## **PROPOSAL**

- Replace the existing siding and trim,
- Demolish a rear wall and construct a rear addition, and
- Alter the fenestration on several elevations.

# Rood Residence

## Alterations + Addition - Historic Work Area Submission

Figure 2: 1927 Sanborn Fire Insurance Map.

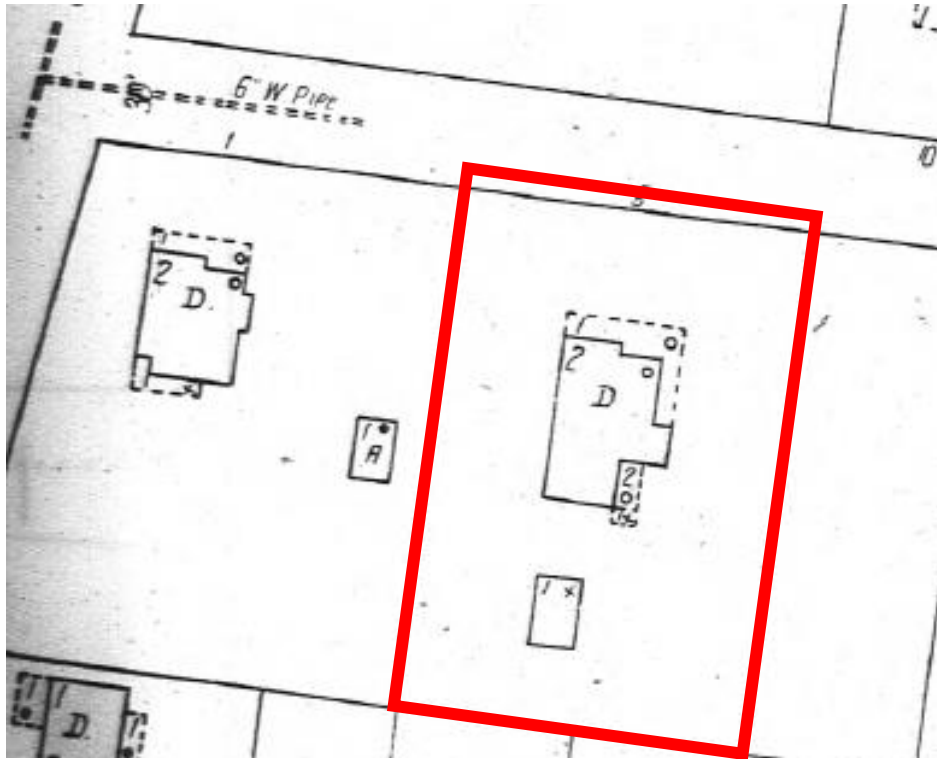
Staff finds the size of the addition will not overwhelm the character of the house or surrounding district. Staff finds the form of the house, particularly at the rear, has been altered from the historic configuration (see Sanborn maps, above). Staff additionally finds that while the HPC generally requires additions to be inset from the historic wall plane by 1' (one foot), this is an instance where a co-planer addition may be acceptable because the rear is already inset by several feet from the historic wall planes. Staff finds these two factors are sufficient to justify an extension of the rear.

3 PROPOSED East Elevation  
3/16" = 1'-0"

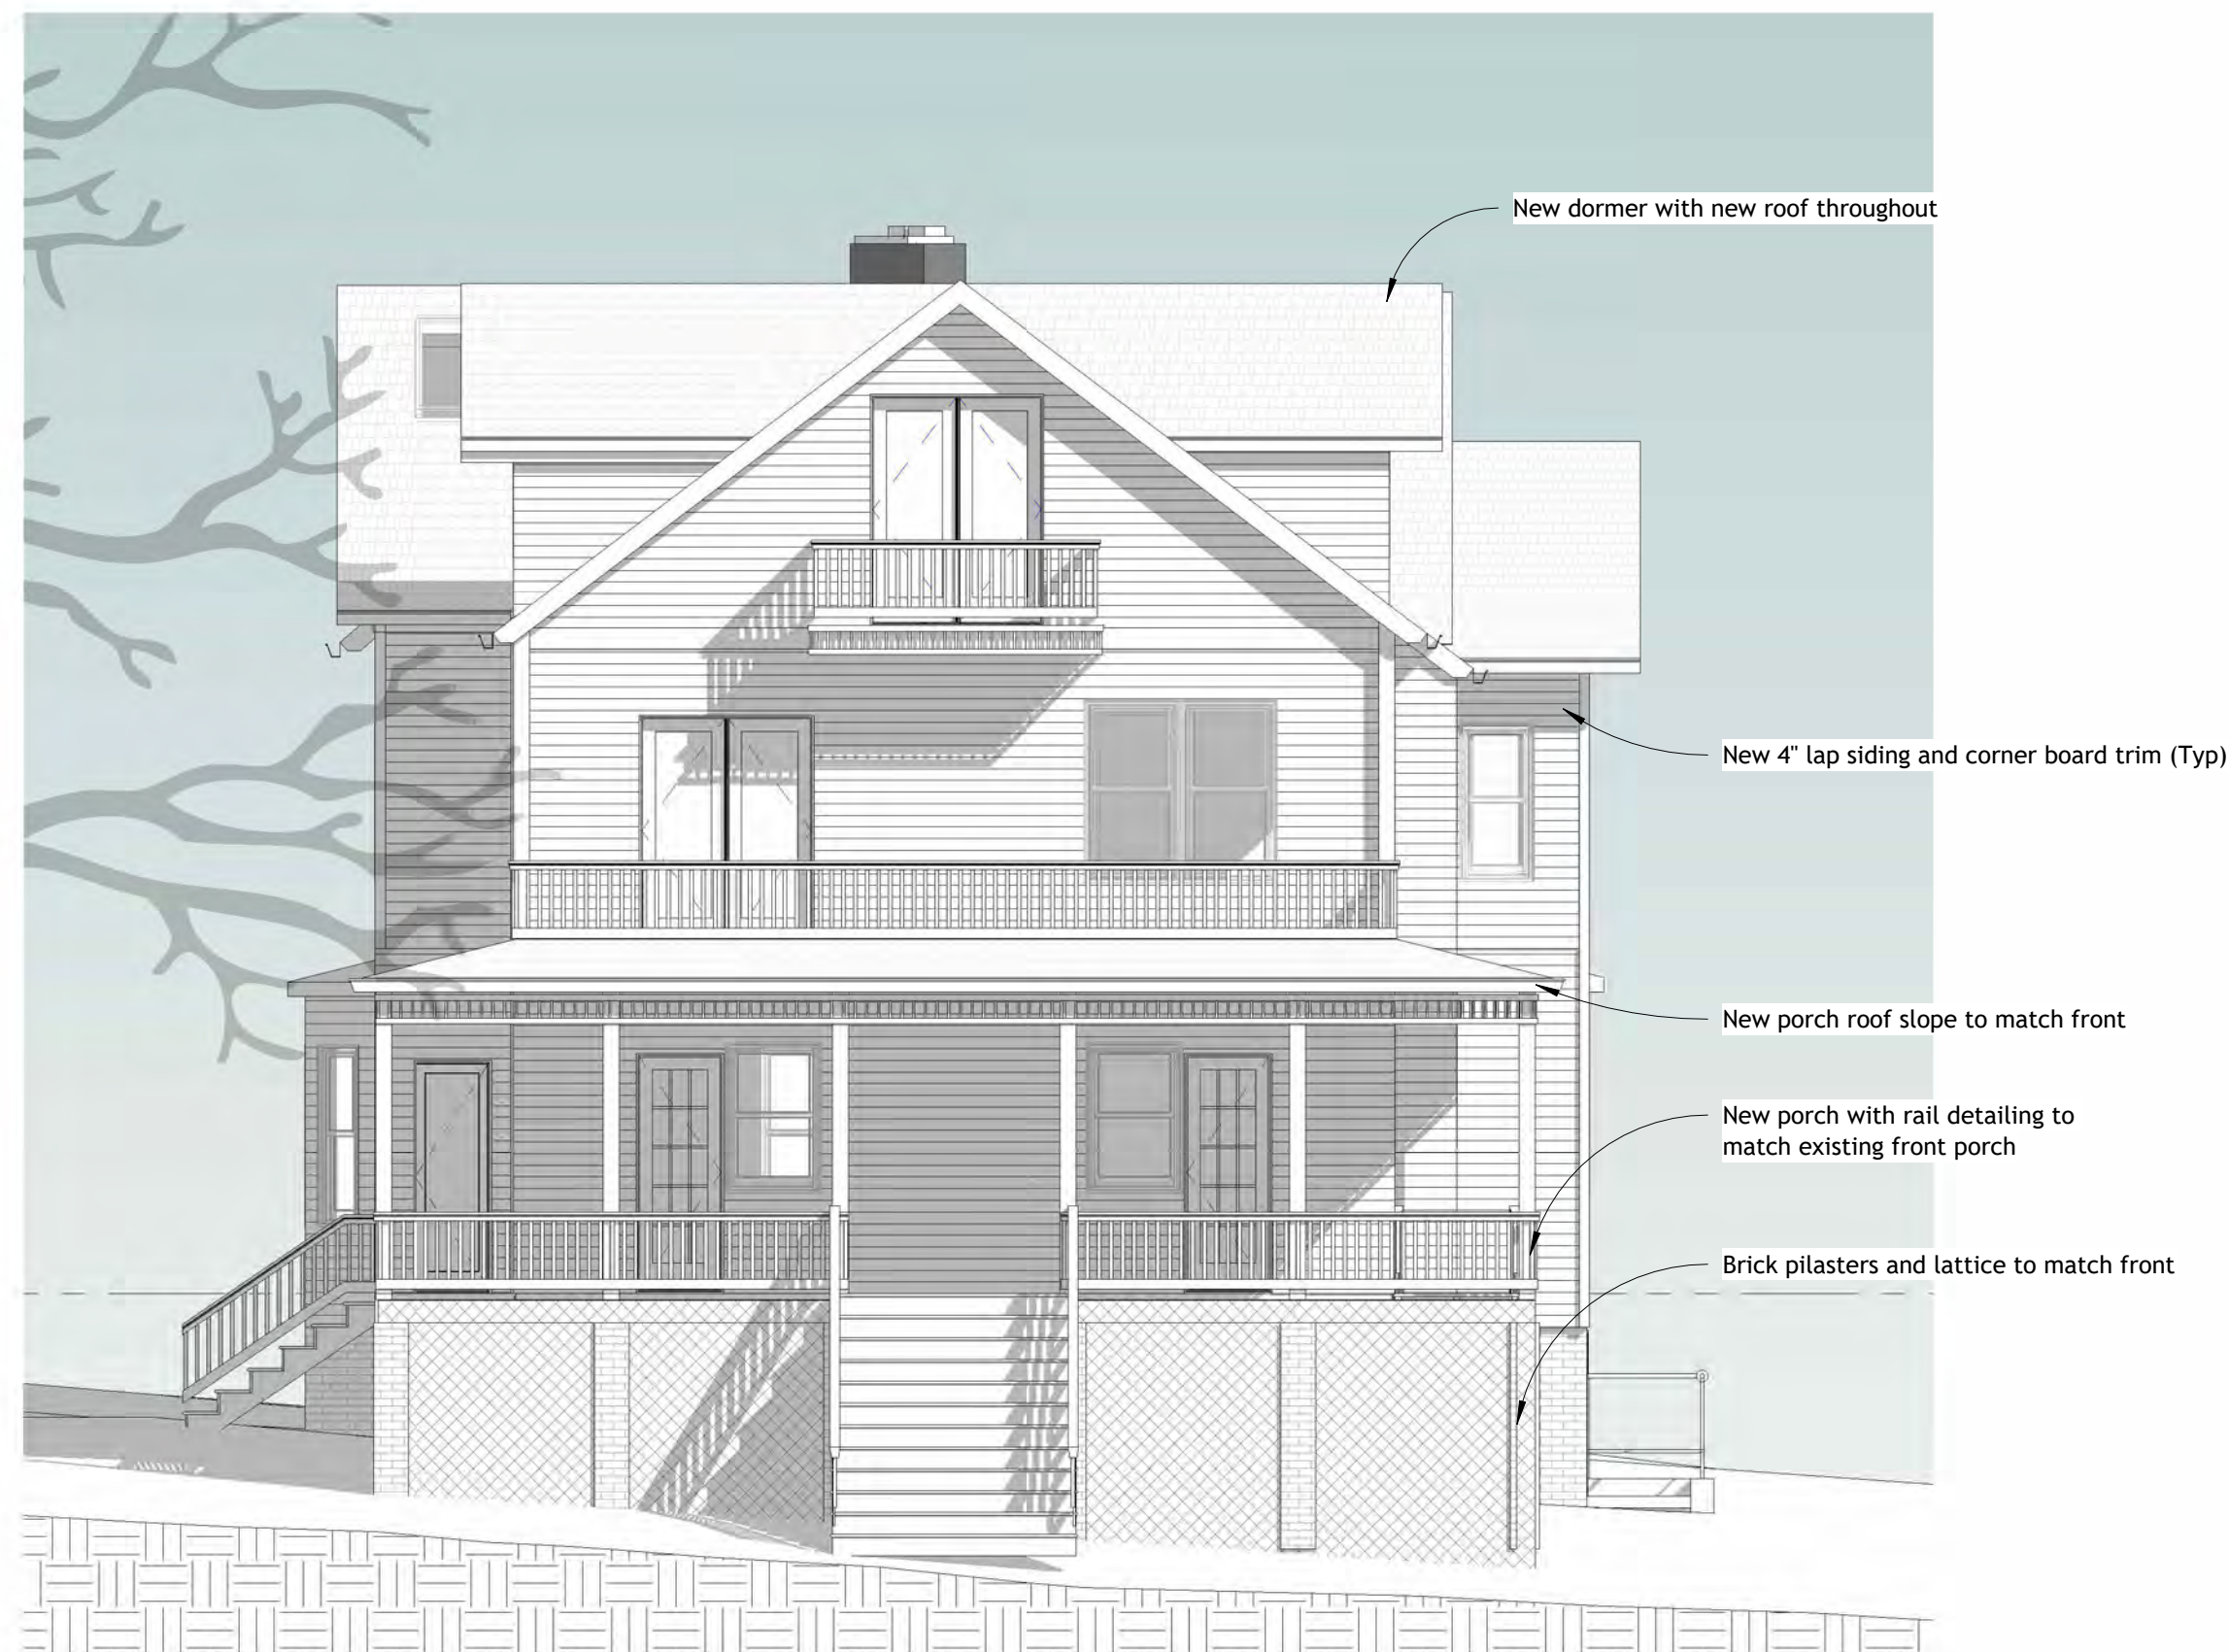
The applicant proposes to construct a bay window on the first floor of the right elevation. There is a paired casement window in this location (omitted from the existing elevation drawings). The hexagonal bay matches the siding and roofing found throughout the house. Staff finds the proposed bay window is generally consistent with the house design, per the *Design Guidelines*, and Staff would recommend the HPC approve its construction as a HAWP application. However, material specifications for the proposed bay were not included with the submitted materials, so Staff cannot provide additional guidance until those materials have been submitted.

The applicant also proposes to change the fenestration on the right elevation toward the rear. There is currently one sash window on this elevation. The applicant proposes installing two sets of paired sash windows along this elevation. Staff finds these windows will not be highly visible from the public right-of-way because of their distance to the rear and because the wall plane is inset by 4' (four feet) from the wall plane at the front of the house. Staff finds that either an appropriately detailed wood or aluminum clad wood window would be appropriate in the proposed location.

Above the proposed bay window, there are two sash windows. The applicant proposes to remove the left of these two windows and block the opening in with replacement siding to accommodate a new interior configuration. The window condition has not been documented.

Staff does not support removing this window. This window is on the side elevation and highly visible from the right-of-way. Additionally, the two windows are grouped under the prominent side gable creating a sense of balance and proportion to the elevation. Staff recommends this window be retained as part of the rehabilitation and notes the window could be blocked from the inside to allow for the proposed interior floorplan.

1 PROPOSED South Elevation  
3/16" = 1'-0"

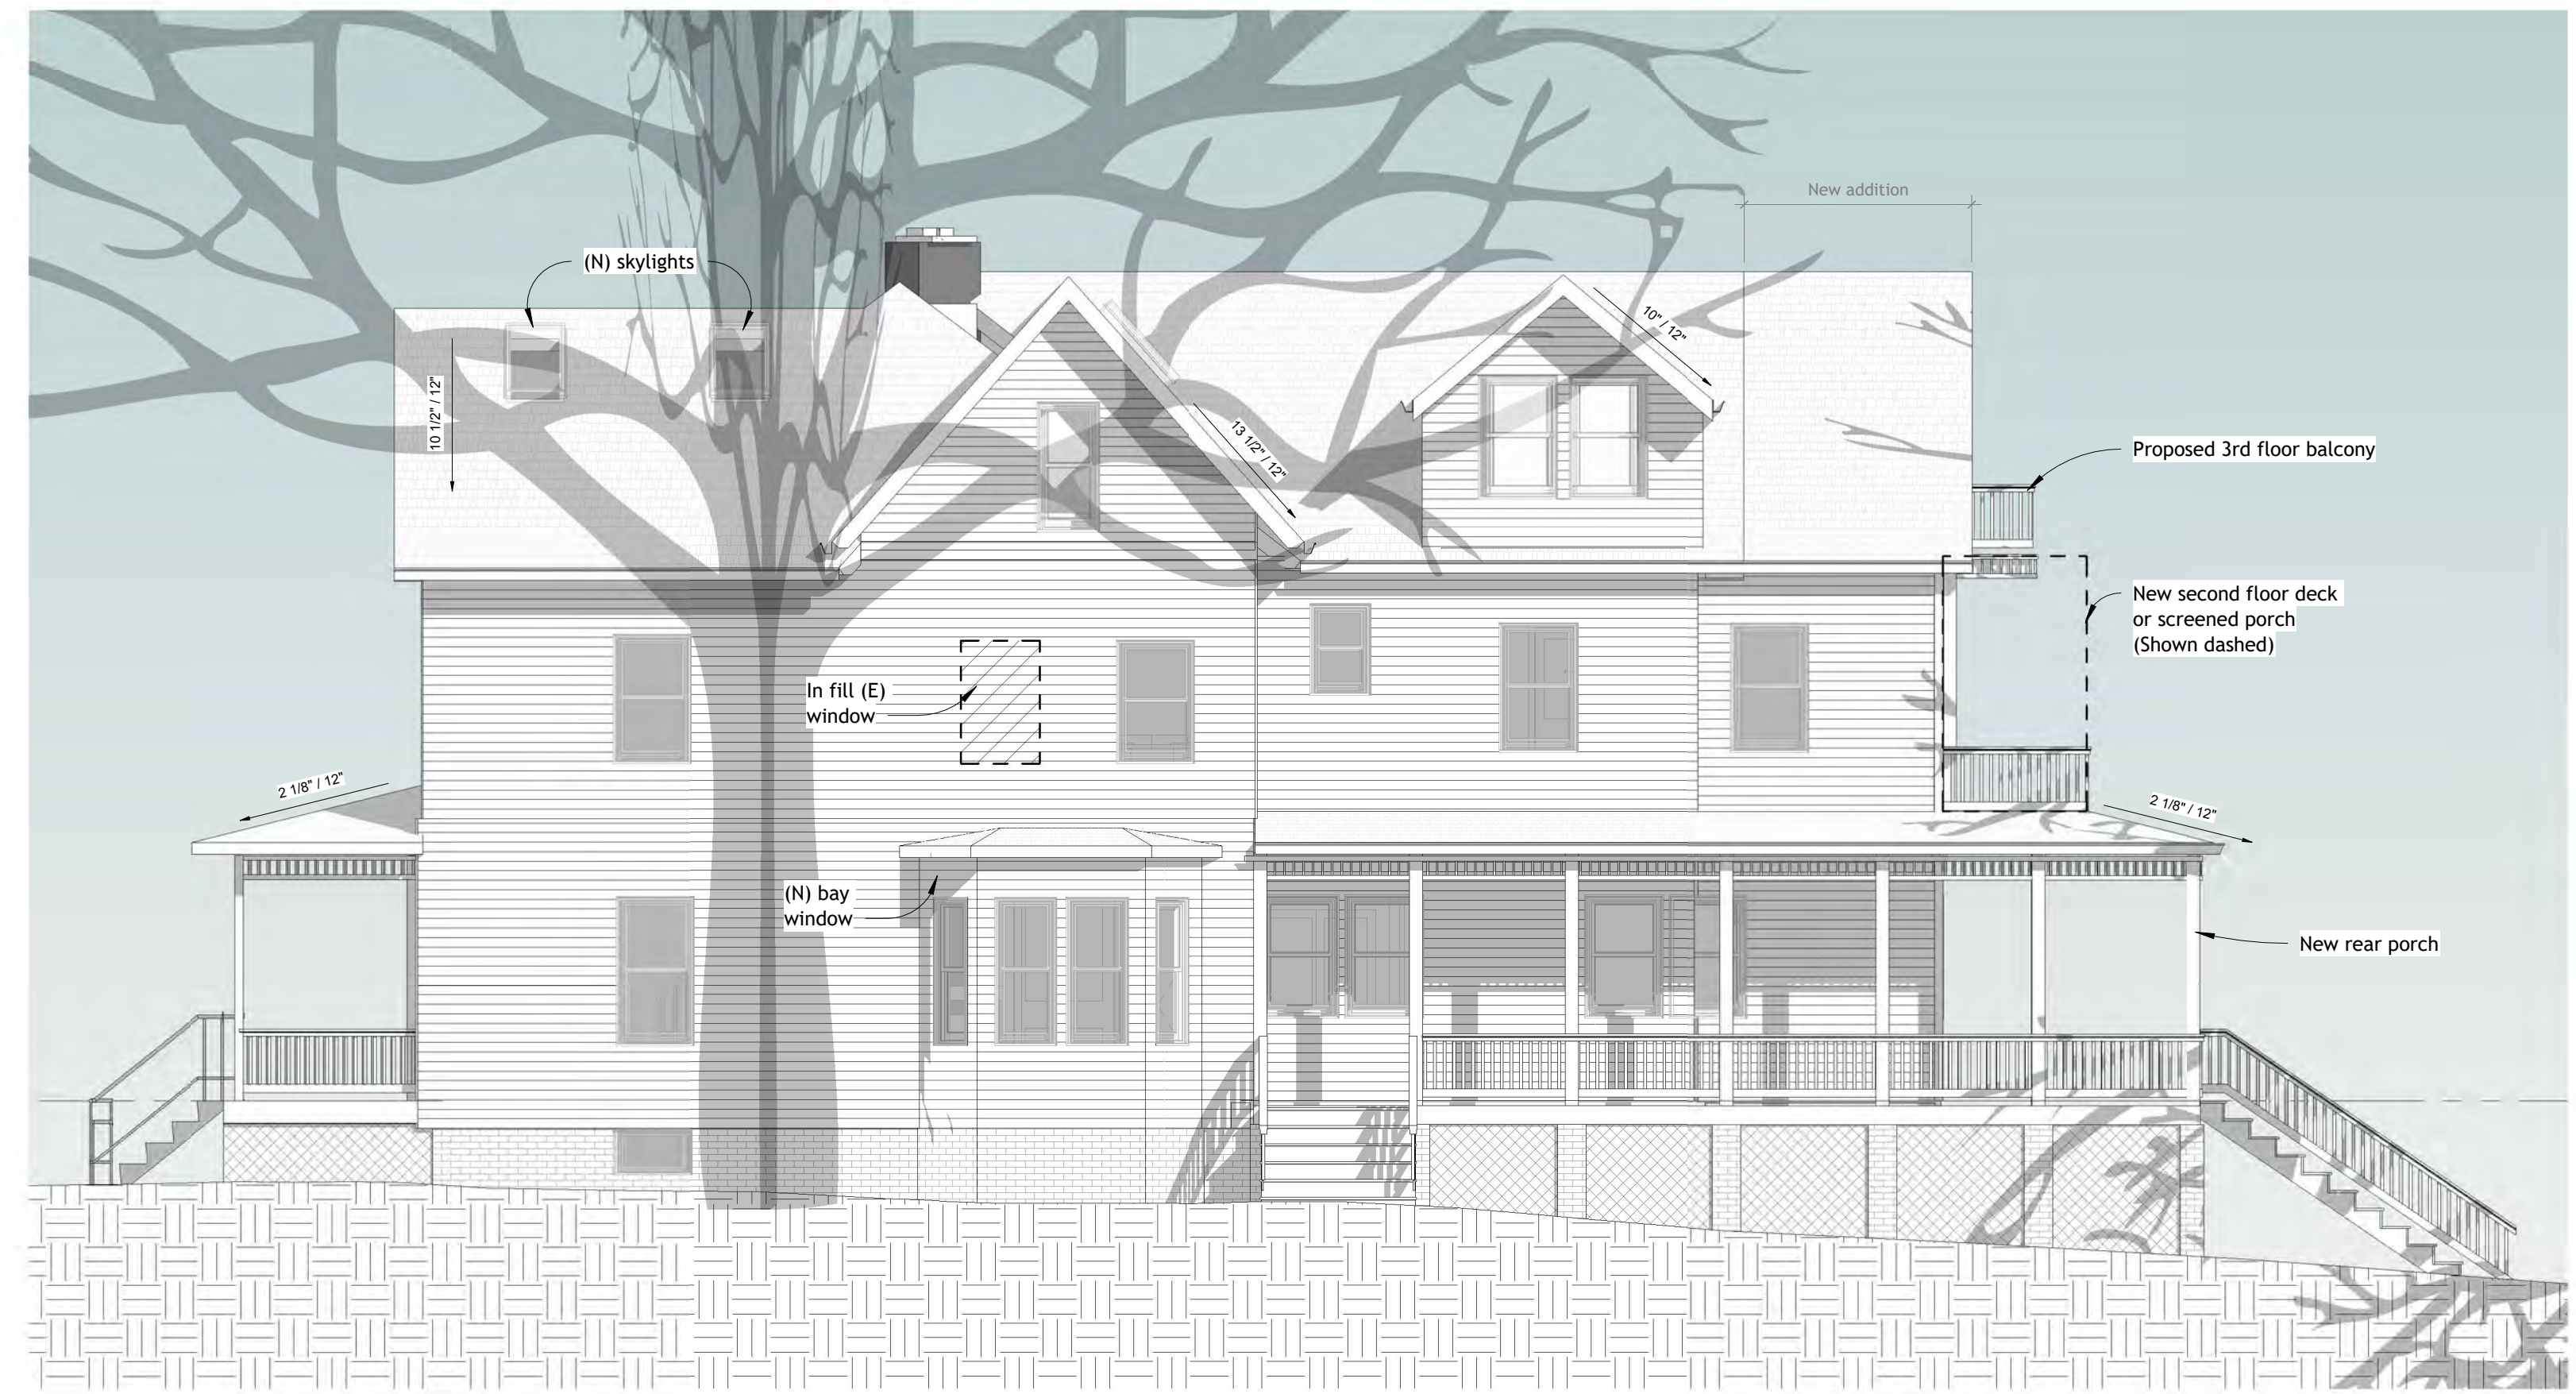
At the rear of the house, the applicant proposes to construct an addition that extends 8' (eight feet) to the rear and is the full width (25' 1 7/8" – twenty-five feet and one and seven-eighths inch) of the existing house. The applicant additionally proposes a wrap-around porch around the sides and rear of the addition. Exterior materials for the addition will match the house exterior (discussed below), however, no roof or windows details were presented with this Preliminary Consultation.

Surrounding the rear addition, the applicant proposes to construct a one-story wrap-around porch. The porch will be built on brick piers that will match the decorative details of the front porch. Because of the lot's slope, the porch will be nearly a full story above grade in certain locations. Staff finds the proposed porch's placement, materials, and design will not negatively impact the architectural character of the house or the surrounding district. The applicants also propose to construct a small balcony in the attic level. Staff finds this element will not be at all visible from the right of way and should be approved as a matter of course.
